### Changes in topside tank configurations that you need to know going forward!!

The new EPA Evaporative Emissions Regulations require Moeller as a fuel tank manufacturer to make several changes to our above deck topside tanks above 12-gallon in capacity to accommodate boats built after 2011:

031615 / 031615BR

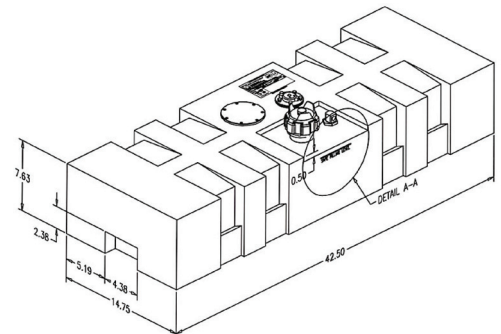
- Each Moeller tank must have a minimum of 5% of the inside volume reserved for ullage open headspace and thus a full fill line is molded in to each tank.

- Tank capacities now reflect the required inside 5% open headspace requirement for both EPA and non-EPA tank models.
- A NEW EPA compliant 2-stage “click when closed” fuel cap is required for the ‘BR’ (Barrier version) model tanks as well.

- The ‘BR’ (Barrier version) tanks are essentially pressured to a minimum of 5 lbs of internal pressure and as a normal process during the daily temperature fluctuations may swell or contract over a typical 24 hour span.

- Moeller utilizes the same mold lid/base for barrier and non-barrier versions thus we have had to install a 3” port in the center of the tank to allow for the barrier material to be loaded during production.

- Replacing the old style Kelch gauge/cap eliminates the ability to have a sight gauge on the barrier version models thus we install a 1-1/2” block off plate in the non-barrier version tank models so we can install a mechanical float gauge in the barrier version models.
